TVA-BFN-TS-431

**BROWNS FERRY NUCLEAR PLANT (BFN) - UNIT 1 - TECHNICAL SPECIFICATIONS (TS) CHANGE TS-431 - REQUEST FOR EXTENDED POWER UPRATE OPERATION- RESPONSE TO NRC REQUESTS FOR ADDITIONAL INFORMATION REGARDING CREDIT FOR CONTAINMENT OVERPRESSURE (TAC NO. MC3812)**

RESPONSE TO QUESTION SPSB-A.11  
FROM NRC LETTER DATED OCTOBER 3, 2005

**FIGURE SPSB-A.11-1: NPSH REQUIREMENTS FOR DBA LOCA - SHORT TERM**

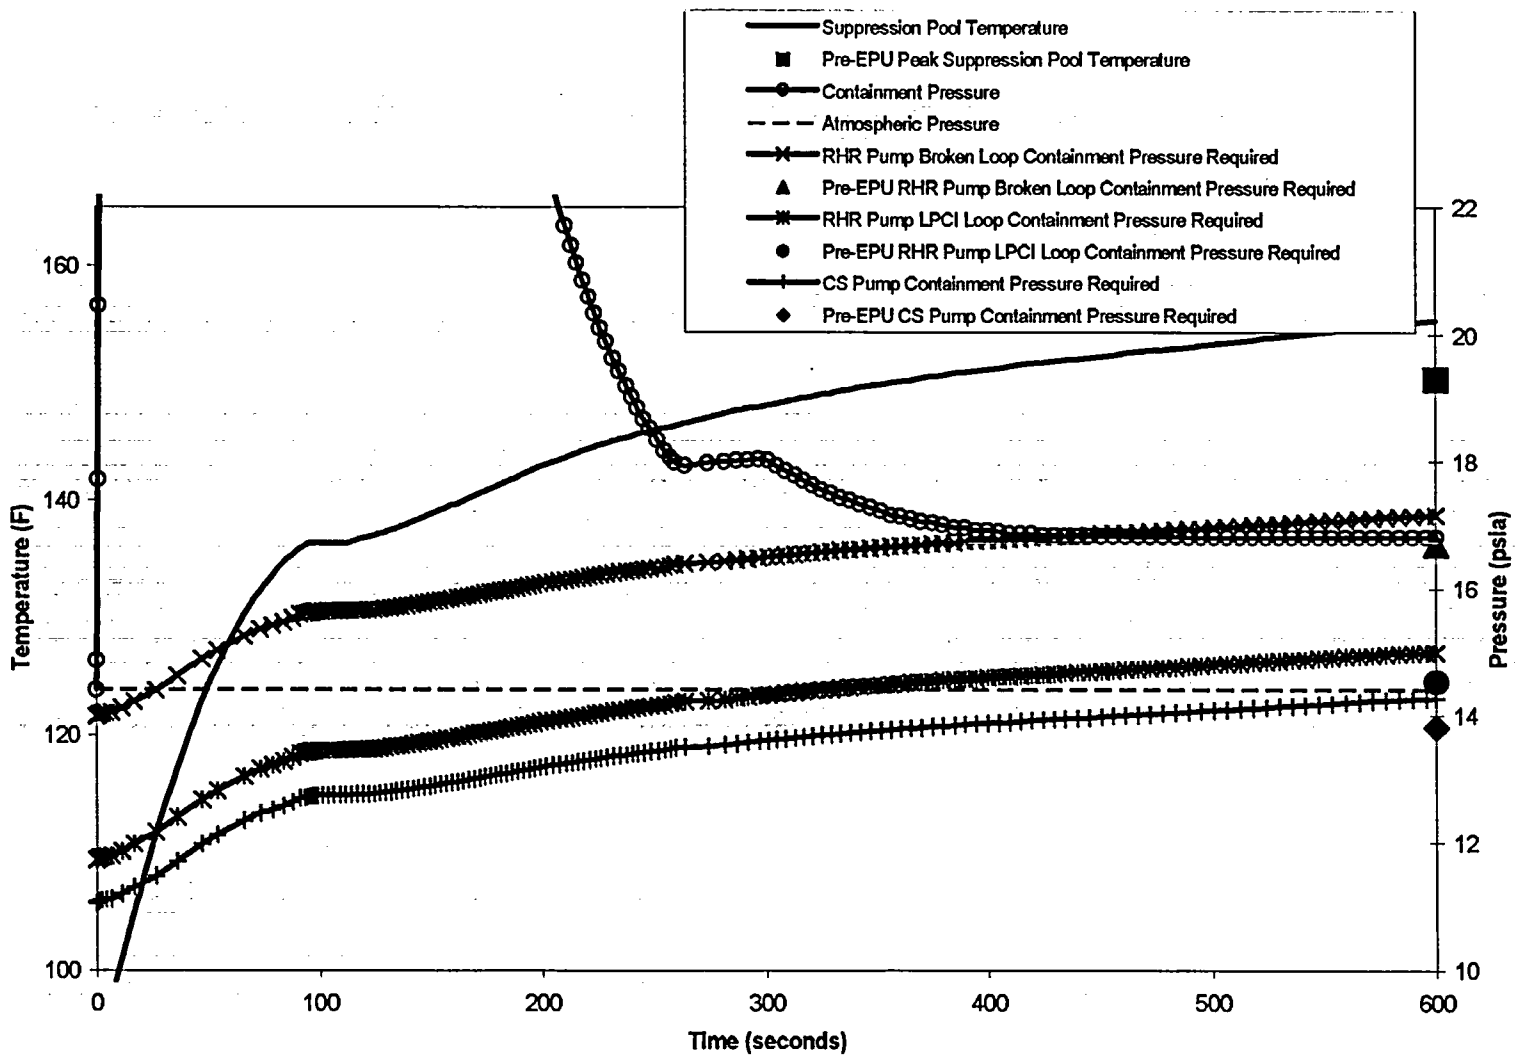
Considering the above discussion, please provide an assessment of the credit for containment accident pressure against the five key principles of risk-informed decision making stated in RG 1.174 and SRP Chapter 19. Specifically, demonstrate that the proposed containment accident pressure credit meets current regulations, is consistent with the defense-in-depth philosophy, maintains sufficient safety margins, results in an increase in core-damage frequency and risk that is small and consistent with the intent of the Commission's Safety Goal Policy Statement, and will be monitored using performance measurement strategies. With respect to the fourth key principle (small increase in risk), provide a quantitative risk assessment that demonstrates that the proposed containment accident pressure credit meets the numerical risk acceptance guidelines in Section 2.2.4 of RG 1.174. This quantitative risk assessment must include specific containment failure mechanisms (e.g., liner failures, penetration failures, primary containment isolation system failures) that cause a loss of containment pressure and subsequent loss of NPSH to the ECCS pumps.

The bounding design basis event for determining NPSH margin is a double ended recirculation discharge line break. This event results in maximum suppression pool temperature and maximum total pump flow. The discharge line break is chosen because the low system resistance on the broken line produces the most limiting flow and NPSH for two RHR pumps which are assumed to be pumping into the broken line inside containment. At the beginning of the event, four RHR pumps and four CS pumps start automatically and align to inject to the Reactor Pressure Vessel (RPV). Two RHR pumps inject to the RPV at 10,000 gpm each, two RHR pumps inject through the broken line into the containment at 11,000 gpm each (greater than design flow), and four CS pumps inject to the RPV at 3,125 gpm each. This mode of operation is assumed for 10 minutes consistent with not crediting operator action for 10 minutes. ECCS strainers are assumed to accumulate the maximum equilibrium debris load. During this time, suppression pool temperature reaches 155.4°F, and only the RHR pumps require credit for COP in order to have sufficient NPSH margin as shown in Figure SPSB-A.11-1.

By comparison to the RHR pumps, the CS pumps would be challenged in the long-term scenario in the event that COP was lost. CS pumps do not require COP in the short-term. (Refer to Figure SPSB-A.11-1). BFN CS pumps are Sulzer-Bingham model 12x16x14.5 CVDS. Assuming no credit for COP, the CS pumps used for long-term core cooling (>10 minutes) would be expected to operate between 27 feet and 21.2 feet of NPSH verses 27 feet used in NPSH calculations for approximately 17.1 hours as suppressior. pool temperature peaks above 171°F during the LOCA. In the unlikely event they become degraded, there is a reasonable likelihood that the affected pumps would still be able to function. In addition, only one of the two CS loops is required to be operated for adequate core cooling and the non-operating CS loop would be available to operators if the operating loop failed after some time period. RHR pumps would also be available in the LPCI mode for core cooling in conjunction with their suppression pool cooling function should all CS pumps become unavailable. COP is not required for RHR pumps in the long-term scenario. Therefore, in the unlikely event that COP was lost in the long-term LOCA, the decay heat removal and core cooling functions would be maintained.
